PERMIT ISSUED		Permit No: 01-0999	Issue Date: AUG 20 2001	CBL: 171 A006022
Location of Construction: 22 Wildwood Cir	Owner Name: Peck Robert R &	Owner Address: 22 Wildwood Cir		Phone: 207-772-3191
Business Name: n/a	Contractor Name: Commercial Property Maintenance	Contractor Address: PO Box 11302 Portland		Phone:
Lessee/Buyer's Name n/a	Phone: n/a	Permit Type: Alterations - Multi Family		Zone: R-5

BUILDING PERMIT REPORT

REASON FOR PERMIT: Extend Closet & add Two Skylights

Ref: Building Permit for 22 Wildwood Circle

yellow is new floor created by this project

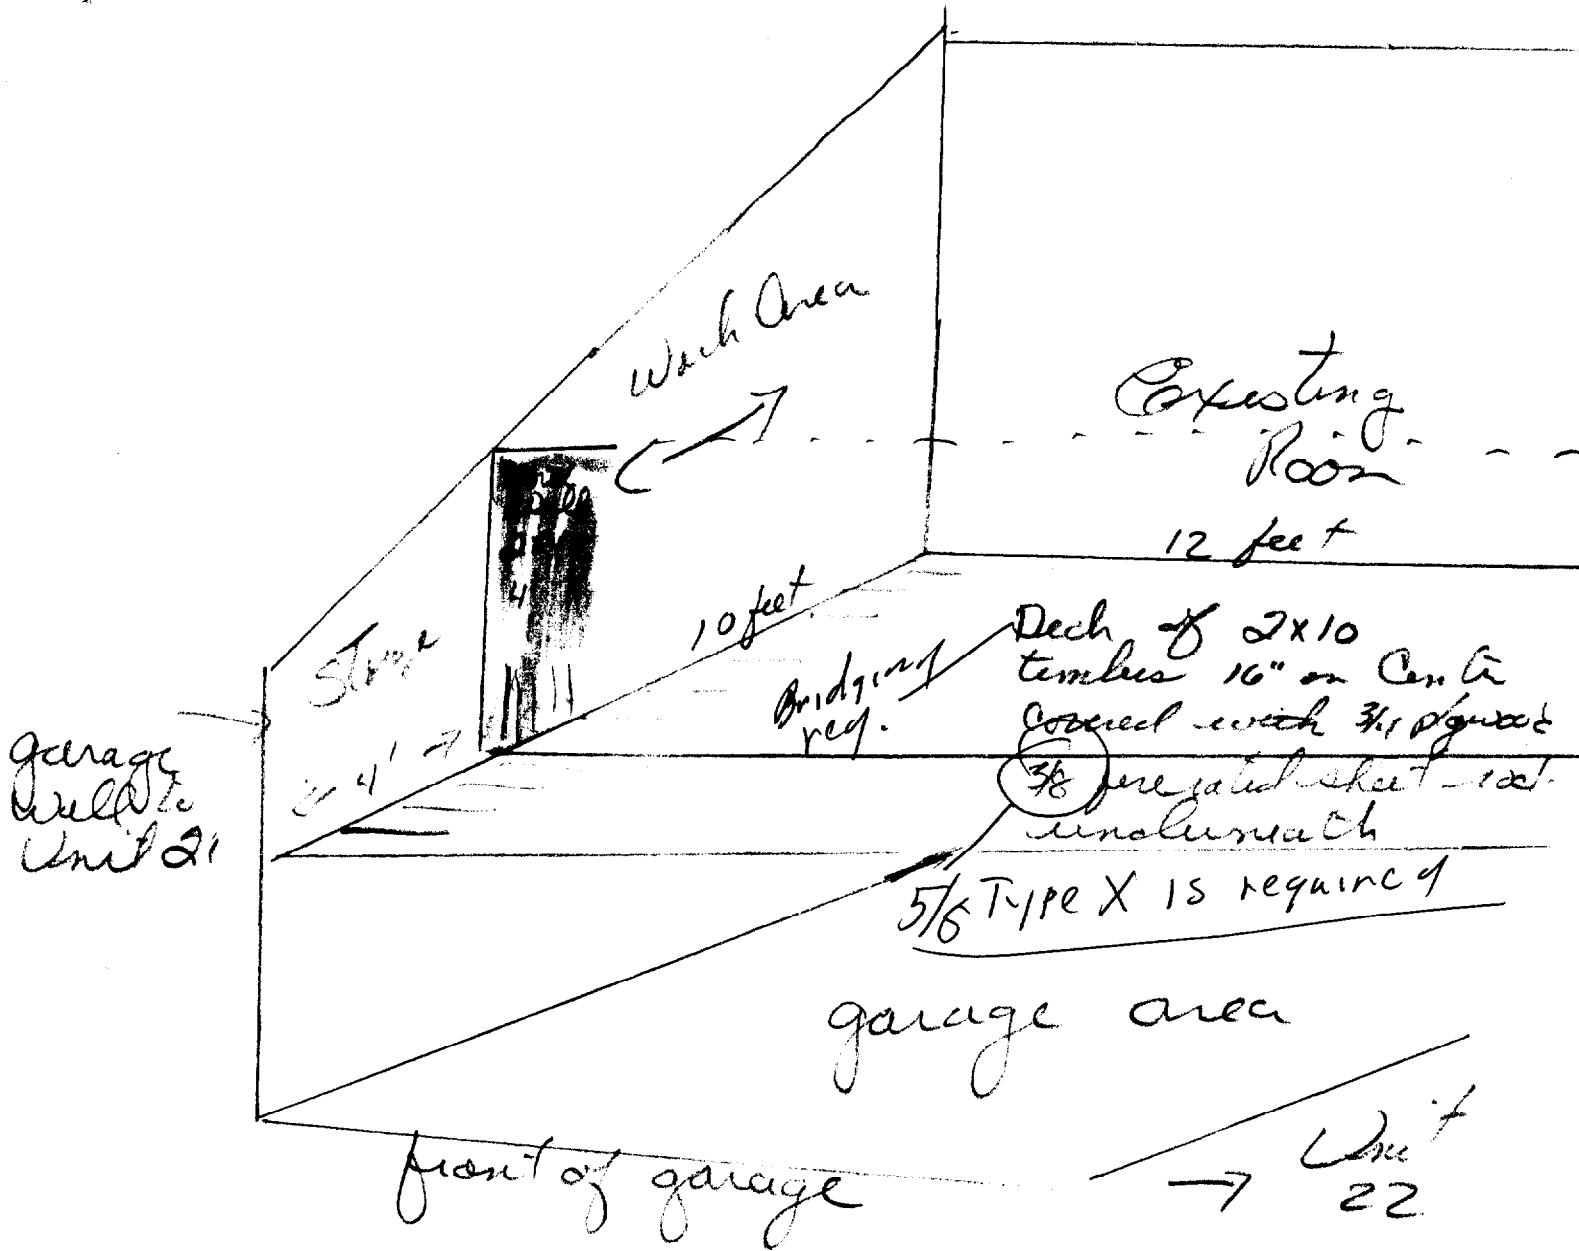
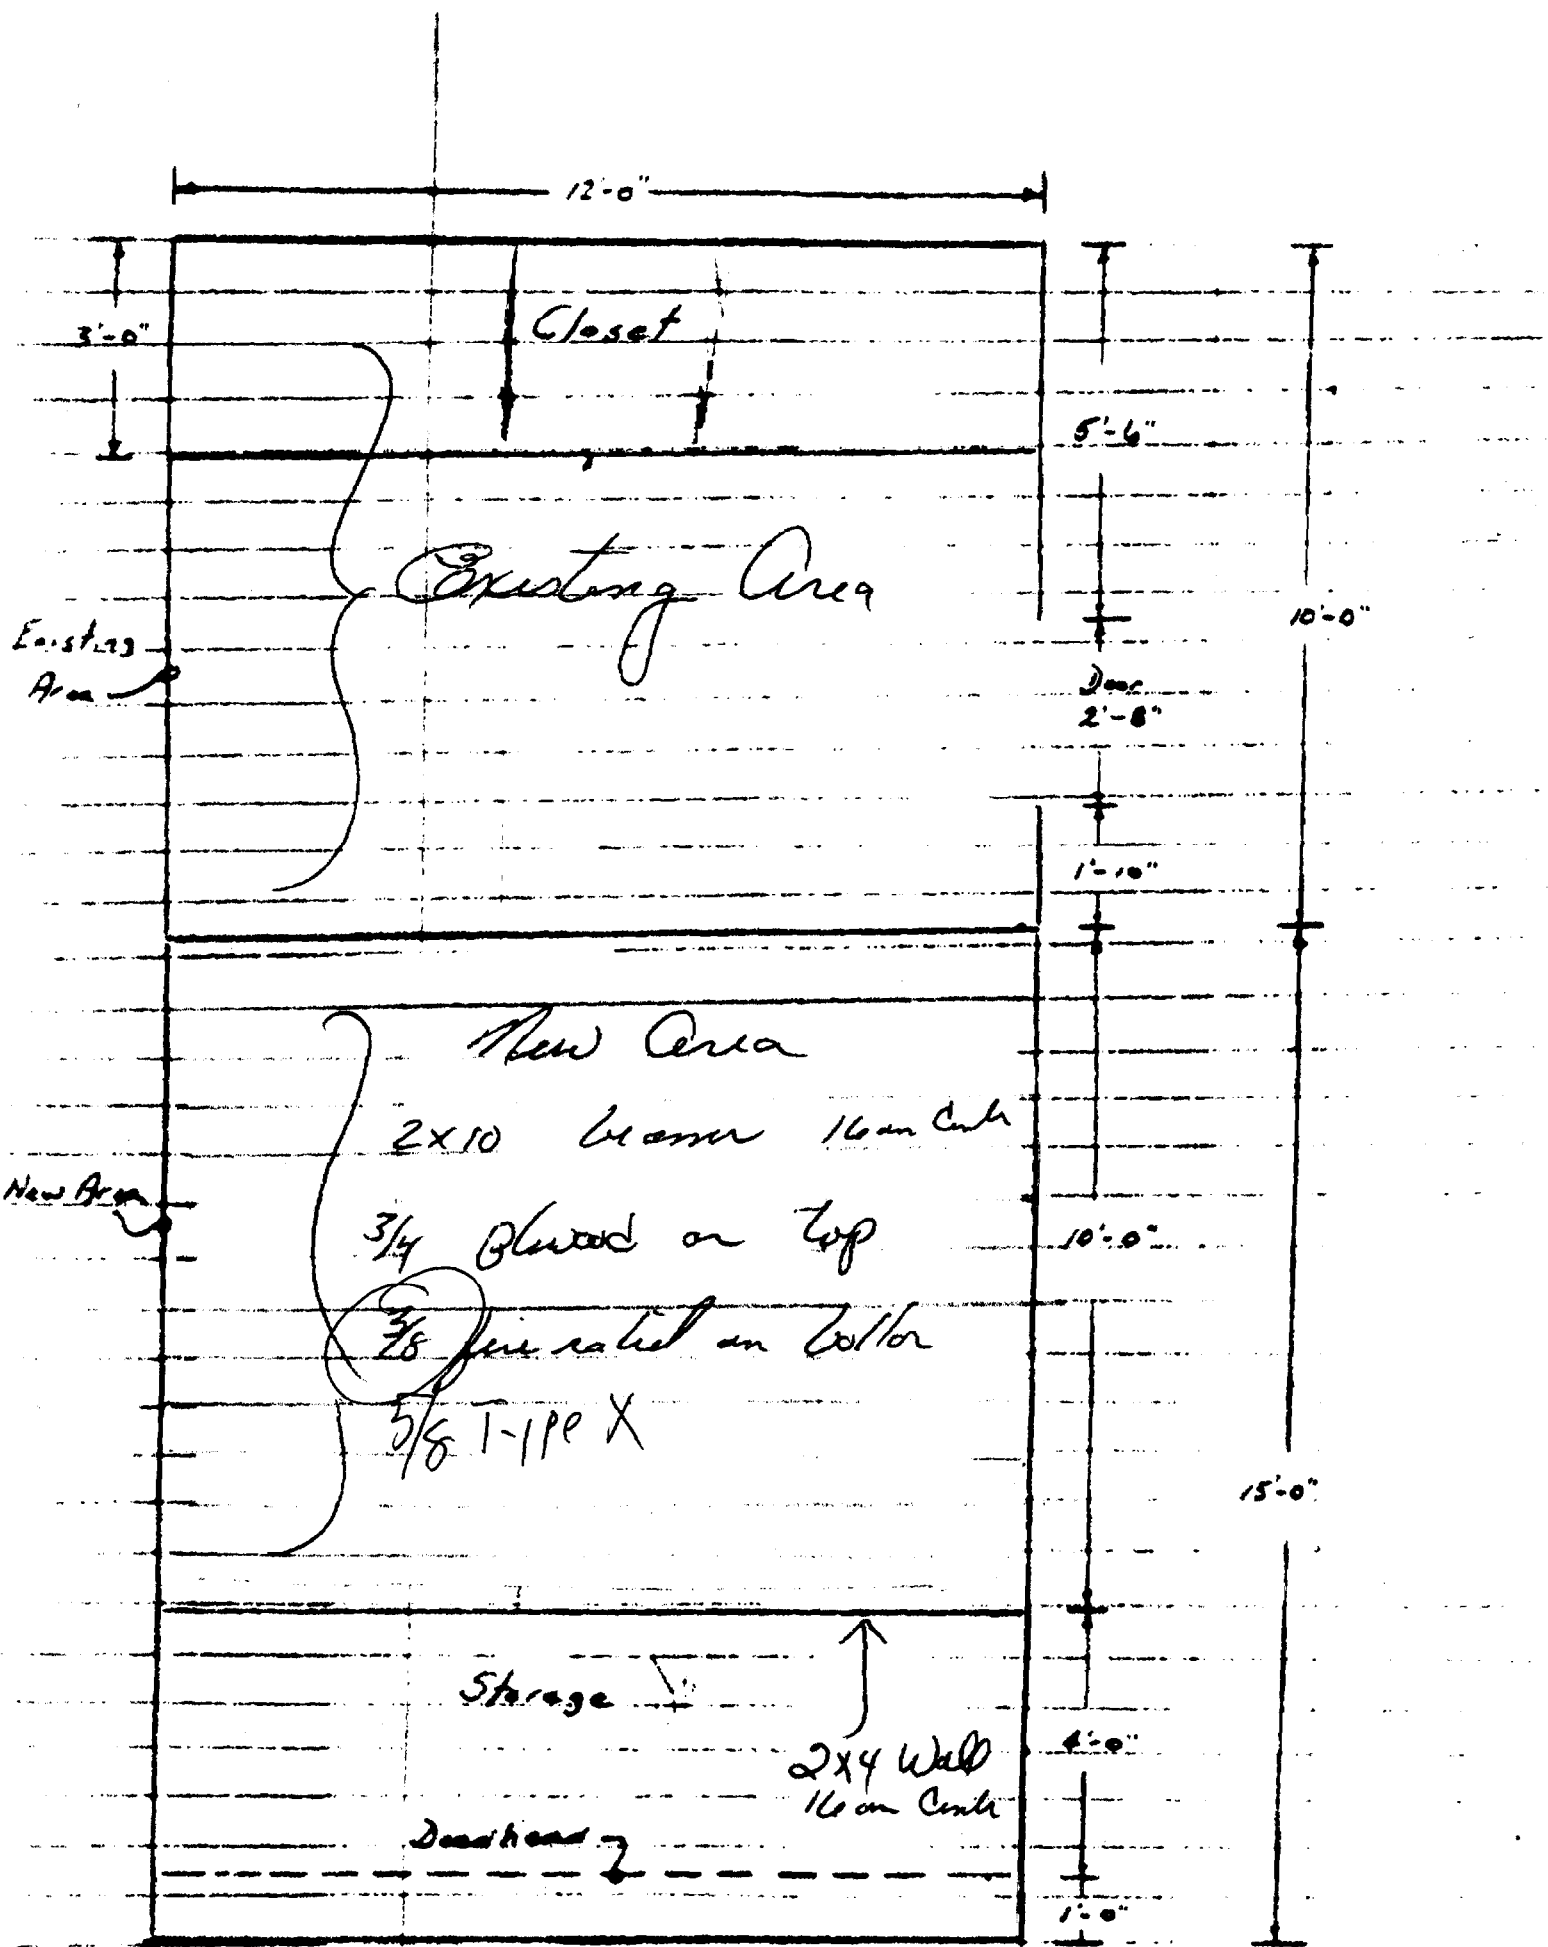
* 38. Your letter dated (no date states) 3/6" Fire rated sheet-rock - to my knowledge, there is no such rating on 3/8" / 5/8" Type X is required.

*No such thing 5/8
5/8 Type X is rated*

5/8 T-1PE X

Placement of 2
new Sky light
(Roof Windows)

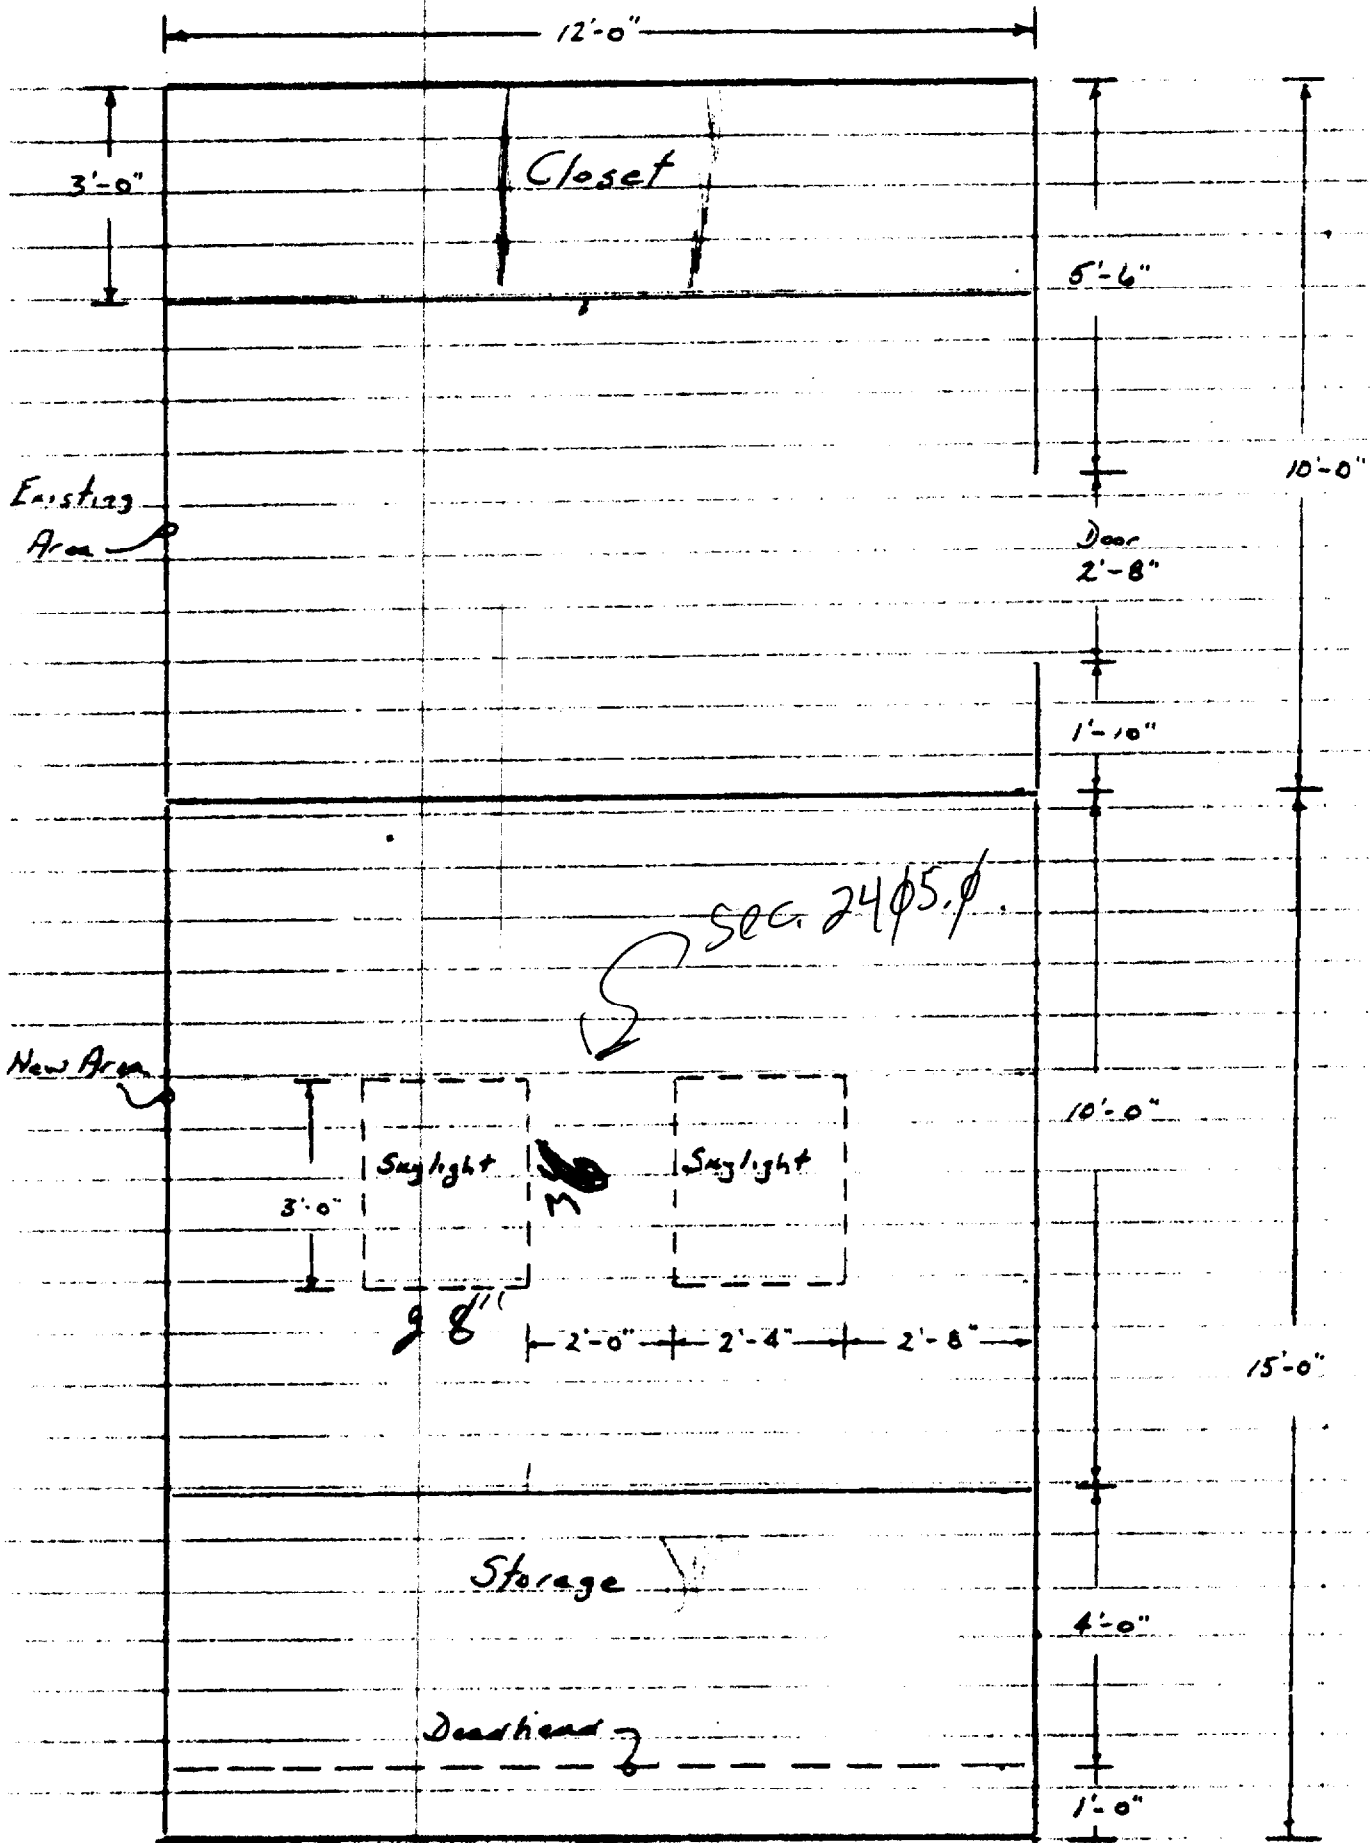
* 39. Framing of new skylight shall require special framing - framing detail shall be submitted before work is started.
